Conceptual Review Agenda

Schedule for 09/14/15 to 09/14/15

Re: 744 Eastdale Dr - Replat

Description of project: This is a request to subdivide and replat the lot at 744 Eastdale Dr (Parcel #9713118014). The subdivision will result in two lots that are each approximately 6,000 square feet. The owner plans to build a single-family home on the newly created lot. The parcel is located in the Neighborhood Conservation - Low Density (NCL) zone district. This proposal will be subject to Administrative (Type I) review.

Plot Plan
LOT 14 EASTDALE PARK SUB.
BLOCK 187
744 EASTDALE DR.
FT COLLINS, CO

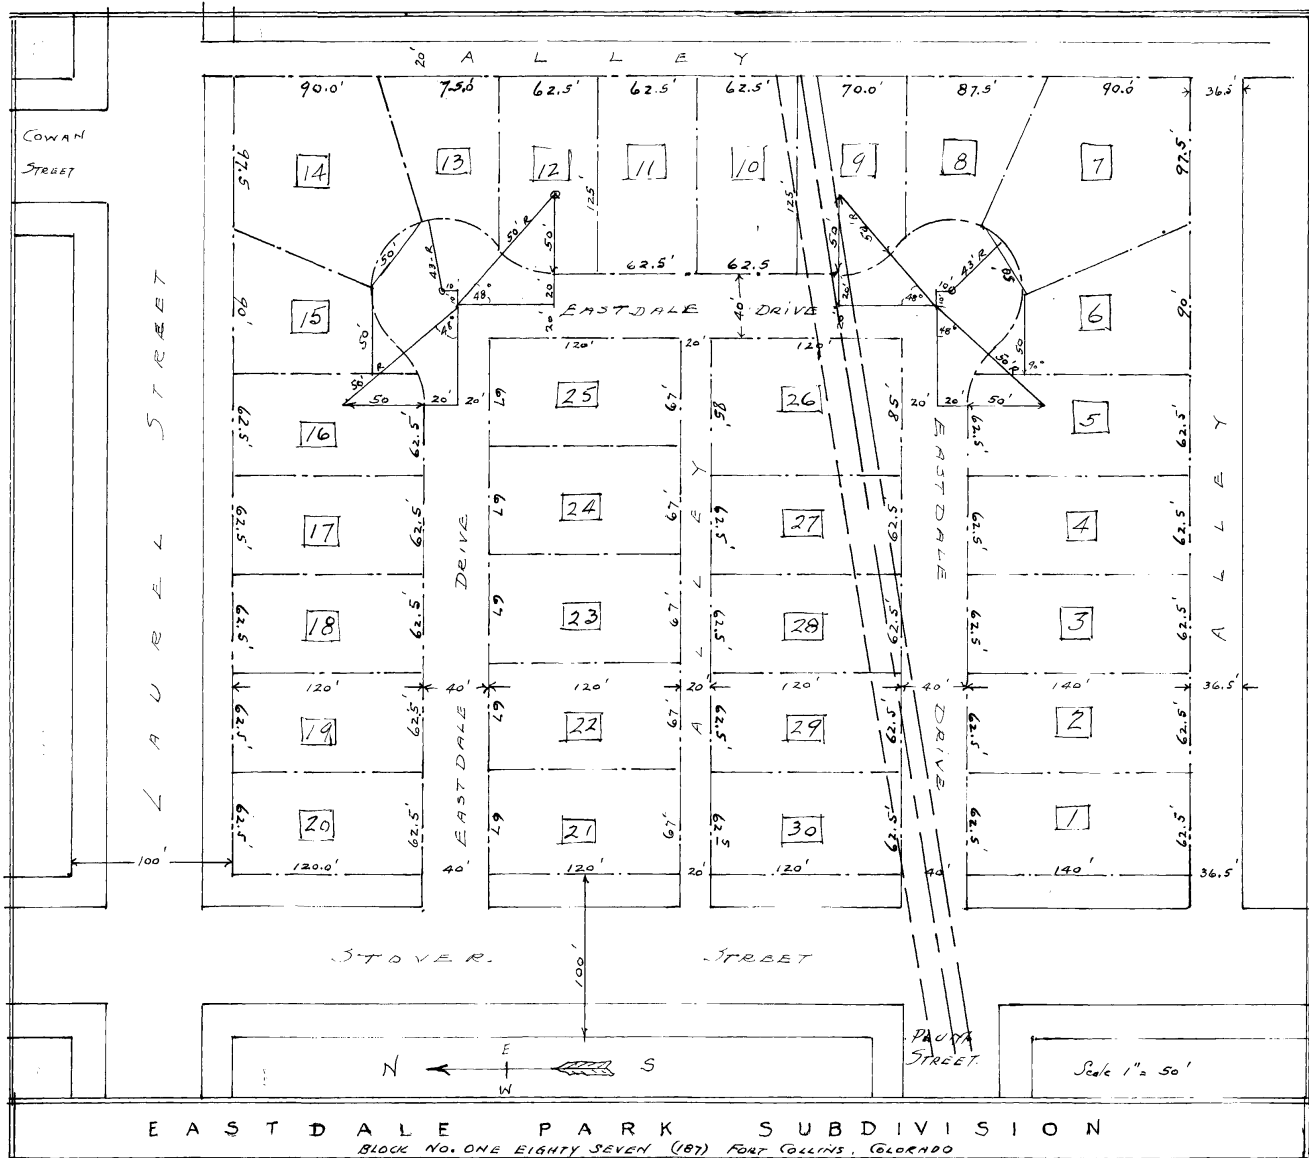
1. NCL zoning requires a 15 front setback, 15 foot rear setback and 5 foot interior side setback.
2. LUC 4.7(F)(7) Subdividing of Existing Lots. No existing lot may be further subdivided in such manner as to create a new lot in the rear portion of the existing lot. This regulation shall not apply to corner lots.

It would appear this proposal is creating a new lot in the rear portion so this would require a modification.

6. It appears that the fence is located within the right-of-way along Laurel Street. The fence shall be relocated to a point outside of the right-of-way and a minimum of 2 feet behind the sidewalk along Laurel Street.

2000 E. Harmony Rd.
Medical Office Building
1:50 - Concept Sketch

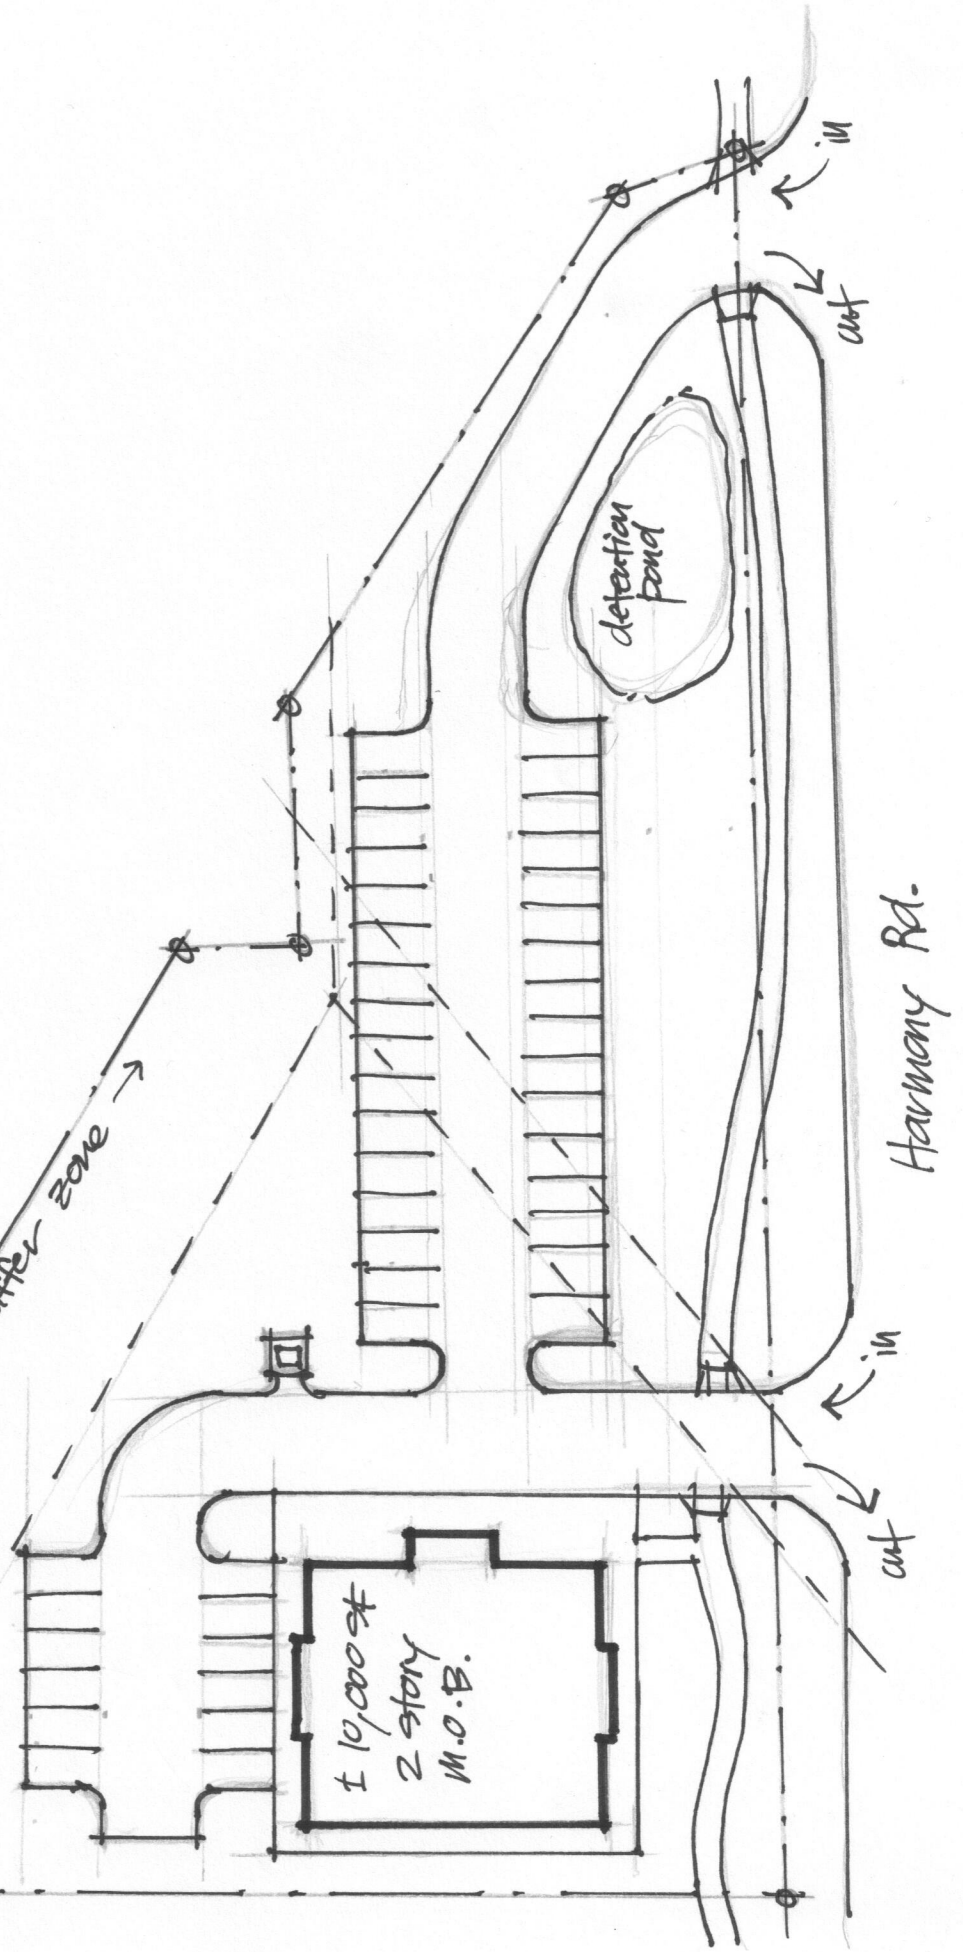
1. Special corridor landscaping is required along Harmony Road. The sketch plan appears to reflect this idea. For discussion at the meeting.
2. The proposed development project is subject to a Type 1 review and public hearing, the decision maker for Type 1 hearings is an Administrative Hearing Officer. The applicant for this development request is not required to hold a neighborhood meeting for a Type 1 hearing, but if you would like to have one to notify your neighbors of the proposal, please let me know and I can help you in setting a date, time and location for a meeting. Neighborhood Meetings are a great way to get public feedback and avoid potential hiccups that may occur later in the review process.

Bucking Horse ODP

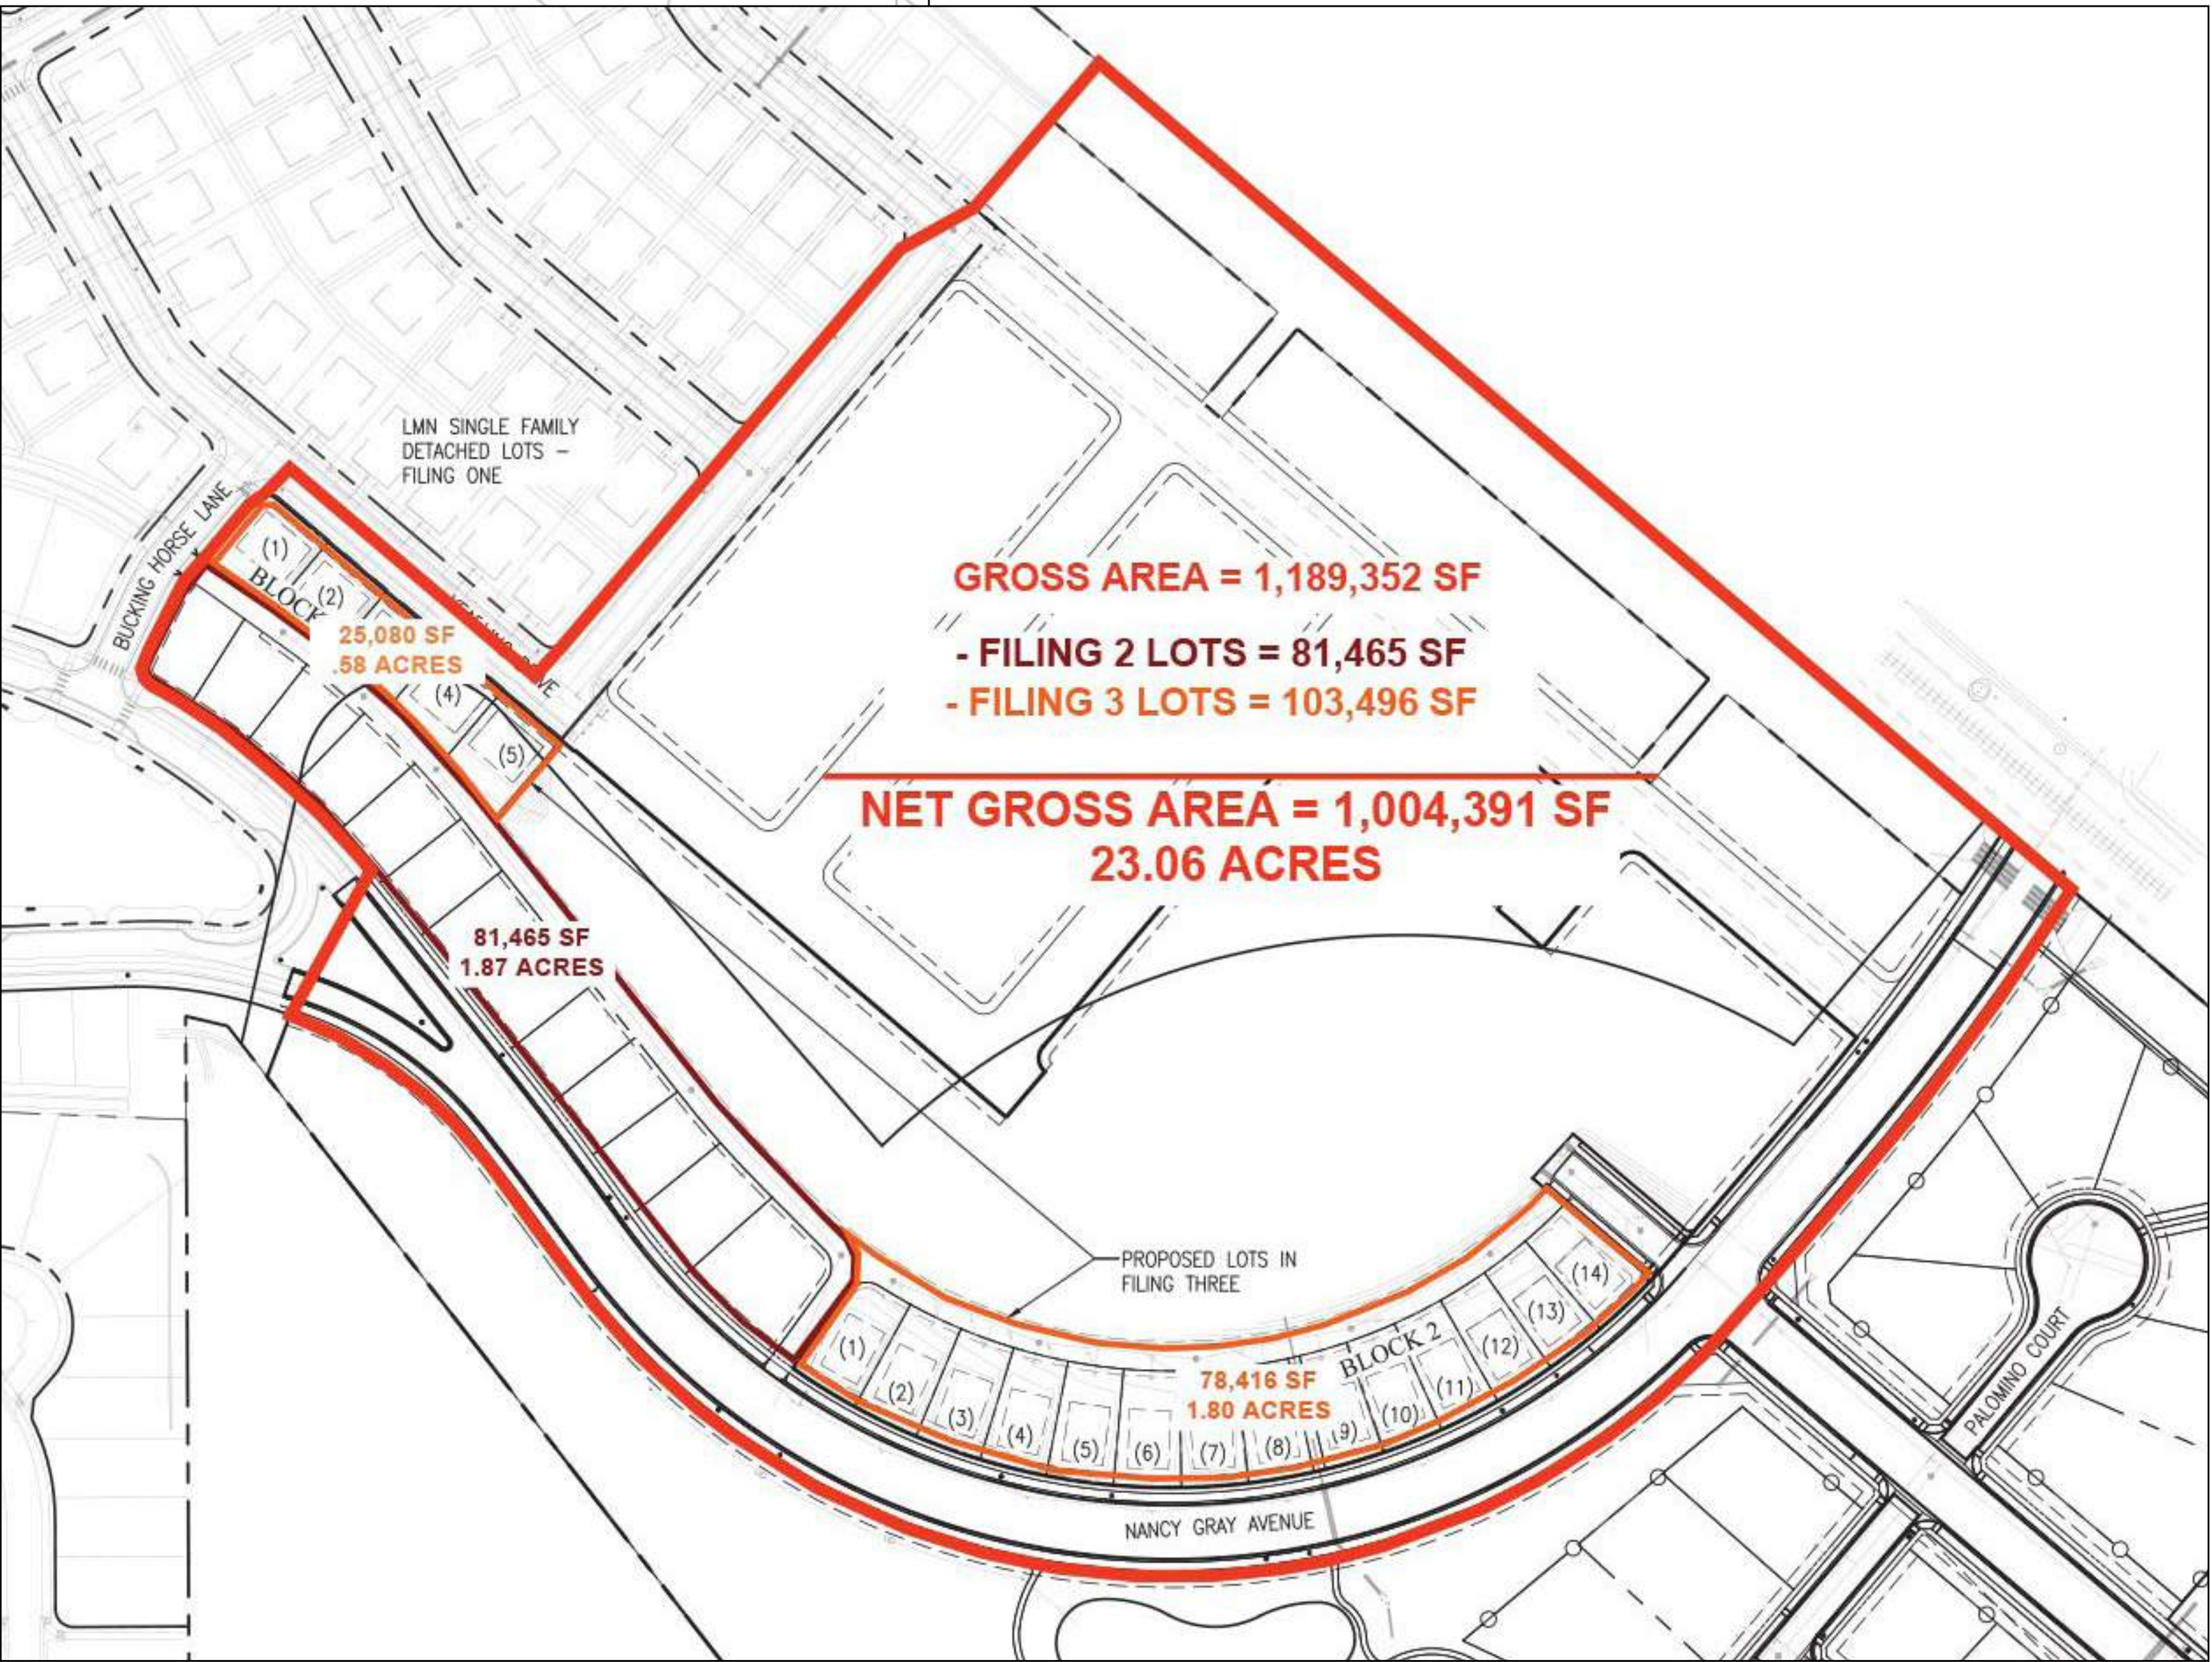
2. As we discussed at Conceptual Review, none of the two-story buildings front on any of the above. If these buildings cannot be shifted to front on the Yearling Drive extension (street-like private drive), then they need to have the connectivity described above. For the buildings closest to the public streets (Yearling and Miles House), it appears that the 200 foot connecting walkway would work. For buildings between 200 and 350 feet away, the major walkway spine would work. For buildings beyond 350 feet, a Modification of Standard may be necessary.

4. Has any consideration been given to providing a direct connection (public street, private street, street-like private drive or private driveway) that aligns with Blue Yonder? Such a connection would provide another point of access and perhaps lessen traffic impacts on Yearling and Cutting Horse. As shown now, there is potential for a significant amount of trips loading up Yearling and Bucking Horse to gain access to Nancy Gray. Such a connection would also provide an opportunity to add a 200-foot connecting walkway or 350-foot major walkway spine if needed to serve the internal buildings. At minimum, if a roadway connection cannot be aligned with Blue Yonder, then a bike / pedestrian walkway should be provided between the two 3-story buildings that front on Gooseberry Lane. This walkway would approximately align with Blue Yonder Way and contribute to integrating the multi-family area into the larger neighborhood.

7. The same comment applies to the connection further to the southeast between Lots 8 and 9, Block 2, Bucking Horse Filing Three. Aligning these connections creates more opportunities for the single and multi-family neighborhoods to be more fully integrated.

11. Has any consideration been given to providing a dwelling unit(s) above the detached garages? By so doing, especially along the railroad tracks, such arrangement would mitigate the regimentation of the long row of garages along the northeast property line. Also, such units would have the added benefit of contributing to the mix of housing types. If provided, be sure that entry points and stairs are visible to drivers traversing the parking lots.
